Designation: D 5985 – 96<sup>€1</sup>

Designation: D 5985 - 02

### Standard Test Method for Pour Point of Petroleum Products (Rotational Method)<sup>1</sup>

FIG. A1.1 Cooling/Heating Block Assembly

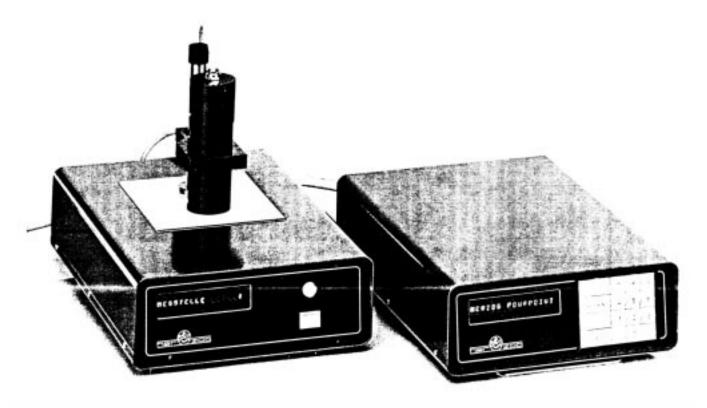
A1.2 Test Specimen Cup, made of aluminum with the following dimensions: aluminum (see Fig. A1.2).
